AGENDA
REGULAR MEETING OF THE BIRMINGHAM PLANNING BOARD
WEDNESDAY JUNE 11, 2025 – 7:30 PM
151 MARTIN ST., CITY COMMISSION ROOM 205, BIRMINGHAM MI*

SUBJECT: 168 W. Maple – Teuta – Final Site Plan & Design Review

SUBJECT: 295 Elm St. – Forest Townhomes – Final Site Plan & Design Review

TRASH PICKUP PLAN
SCALE: 3/16" = 1'-0"

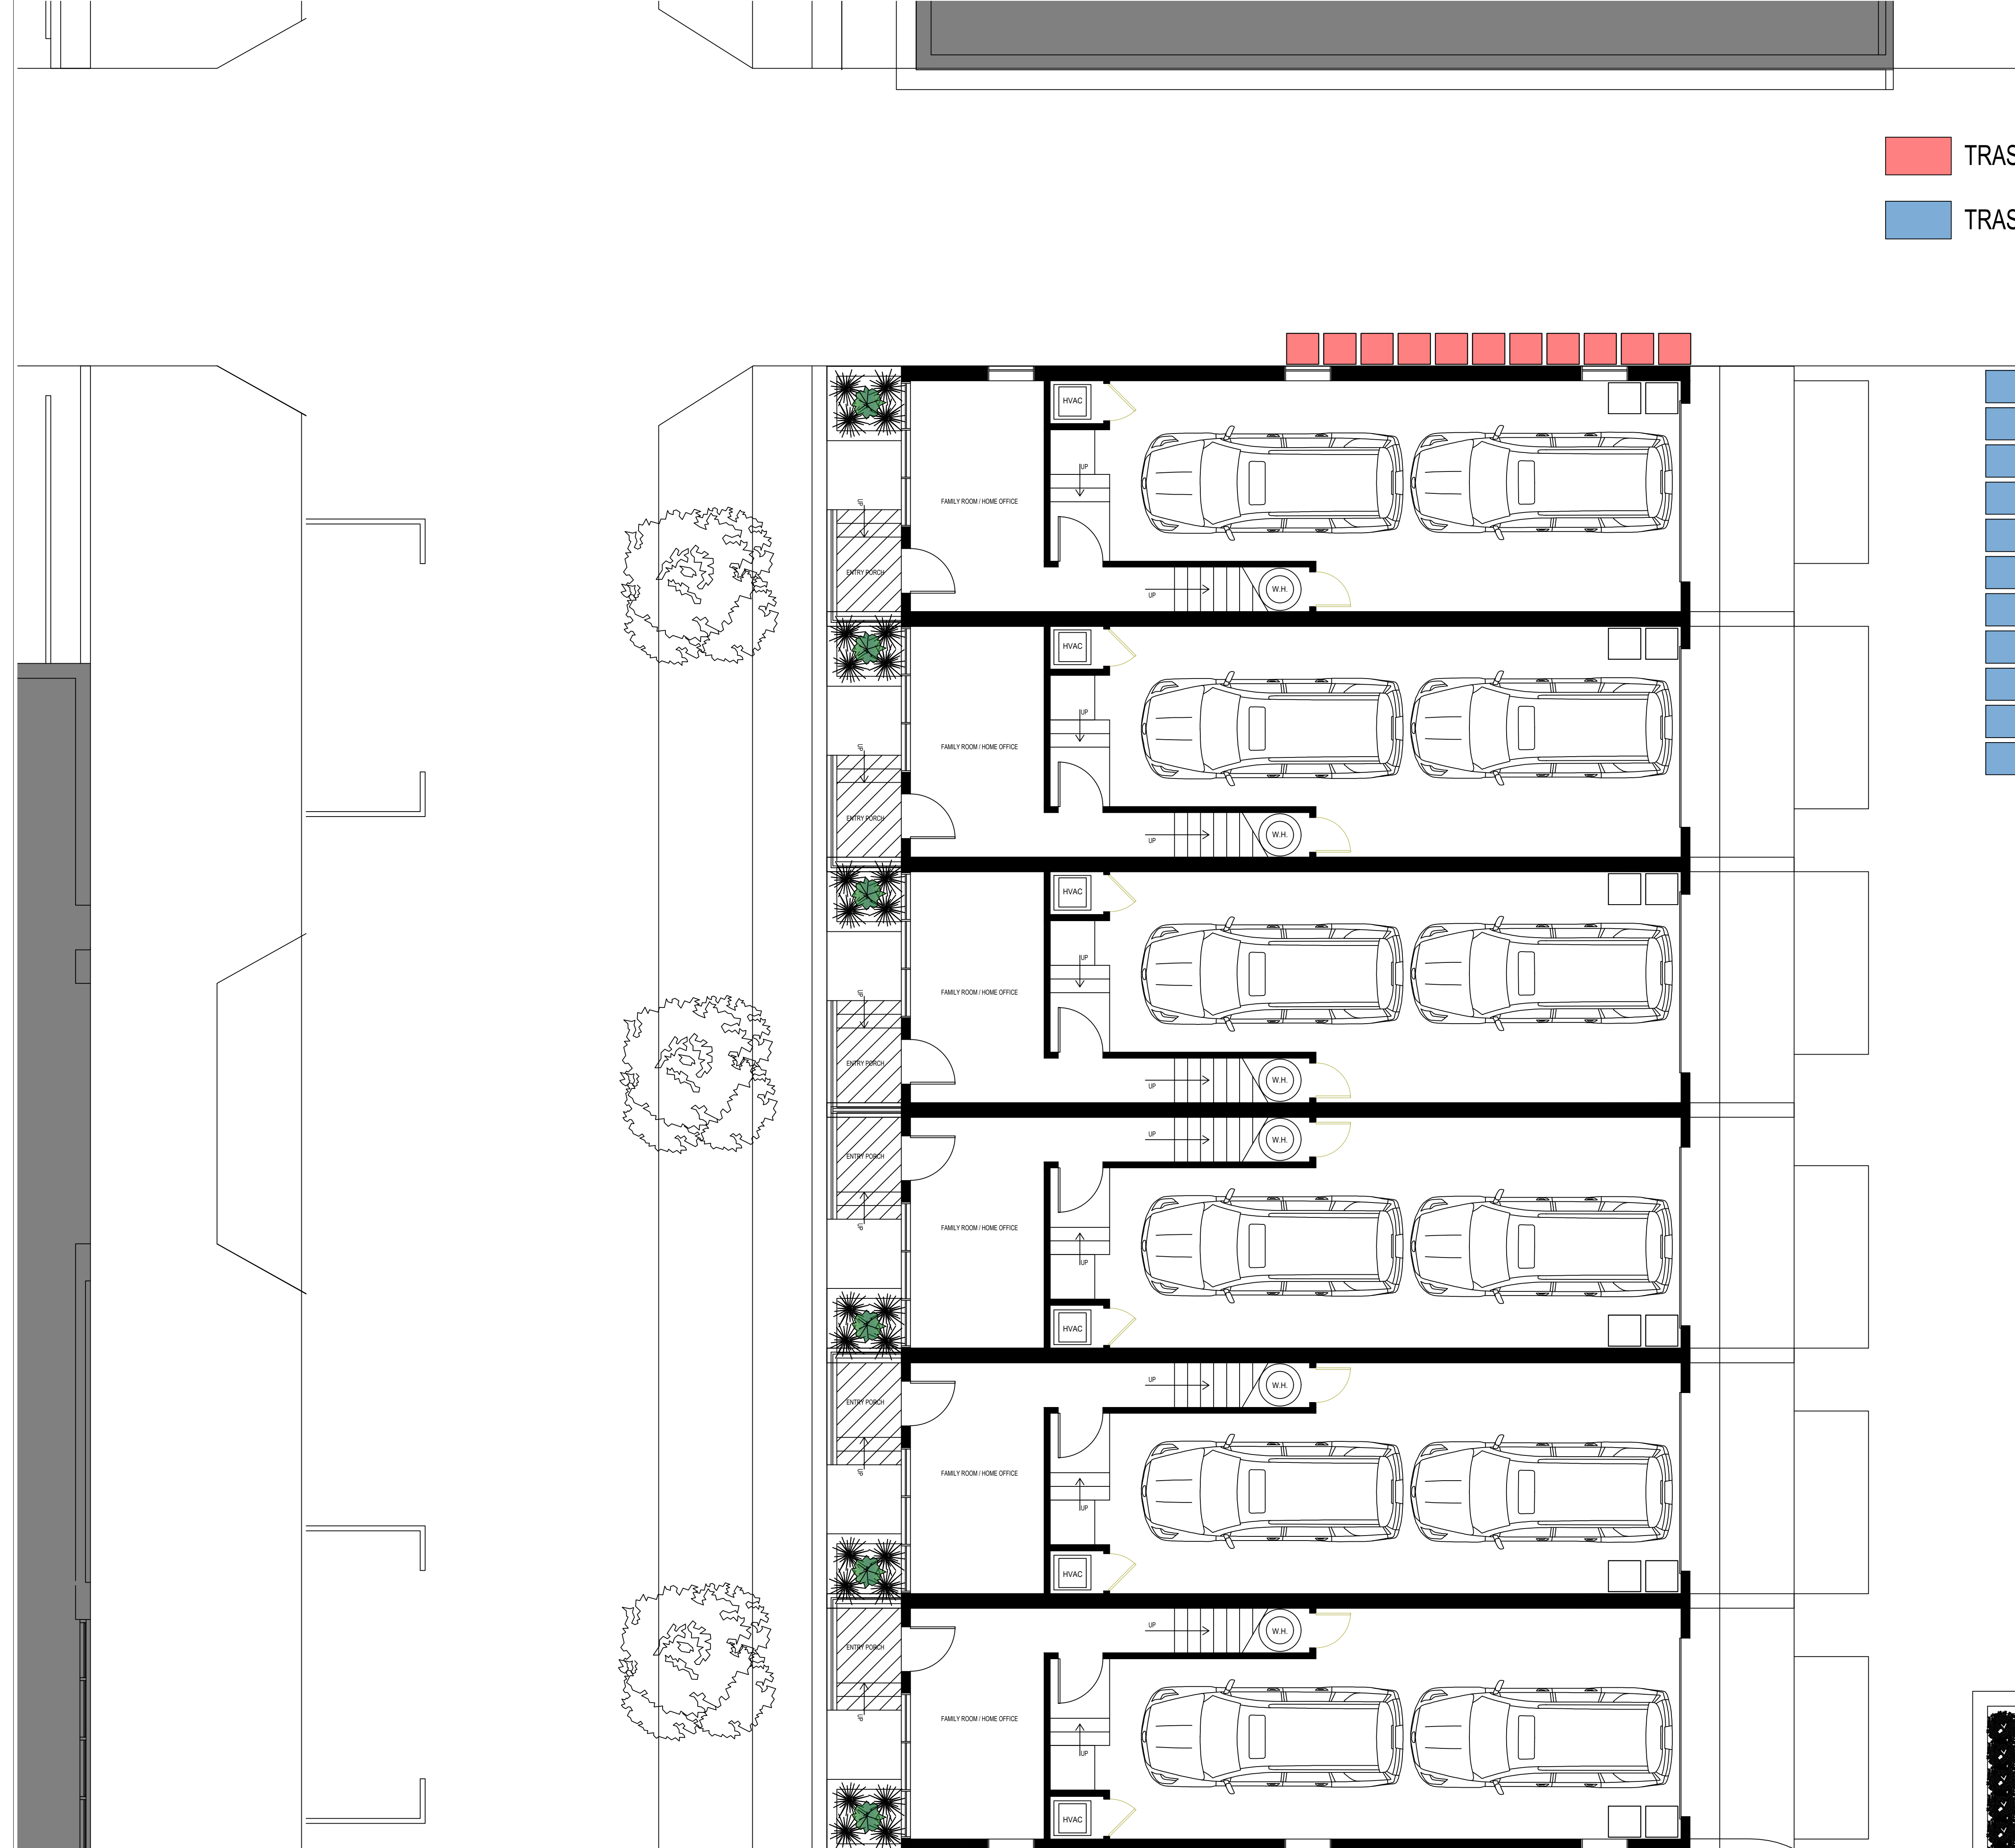
- 4.1 Dumpster Screening – The site plans submitted do not show a common waste storage area on the site. As is typically seen with these types of developments, trash is stored within the garage of each attached single-family unit. The applicant confirmed at preliminary site plan review that trash would be stored in roll-out bins in each individual unit's garage. The waste receptacles will be screened from view by the building.

PHOTOMETRIC PLAN
SCALE: 3/16" = 1'-0"

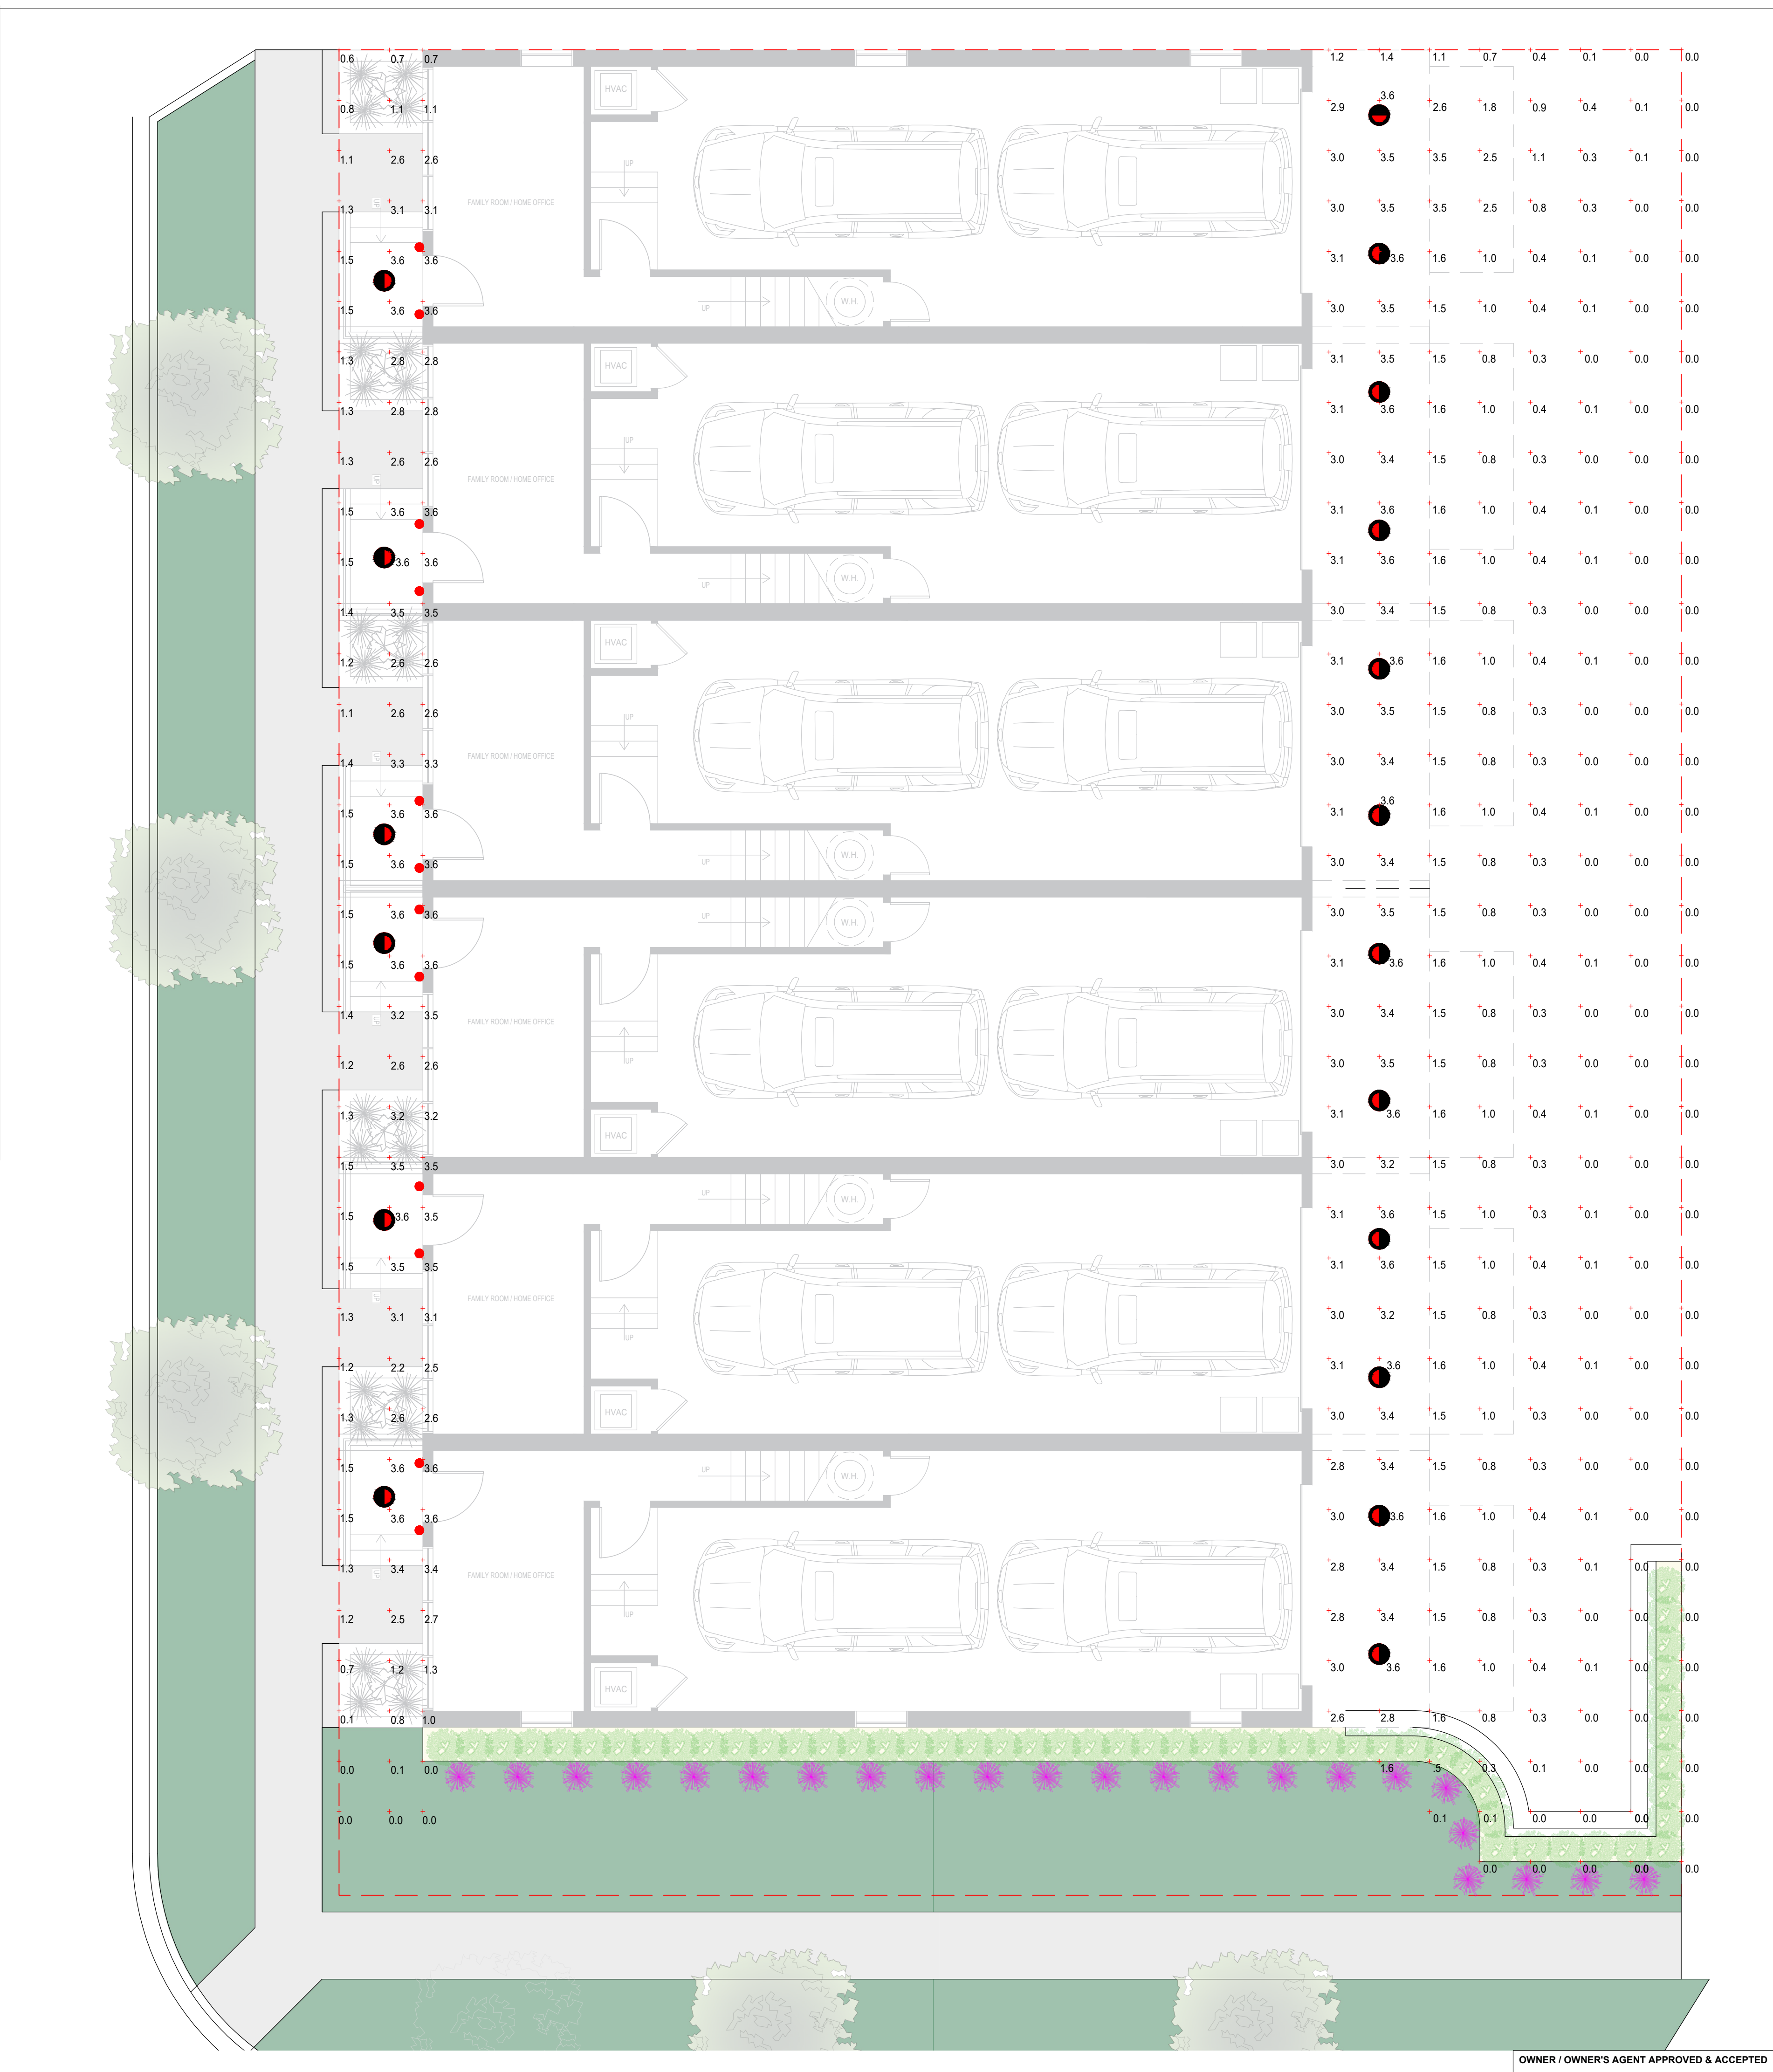
The applicant has submitted a basic exterior lighting design concept that consists of recessed lighting on the upper levels and wall sconces at the unit entrances, as well as specification sheets for proposed light fixtures. It appears that the lighting fixtures currently proposed are slightly different than those included in the previously approved site plans. At this time, the applicant has submitted a photometric plan that appears to meet the ordinance for illuminance levels at all property lines.
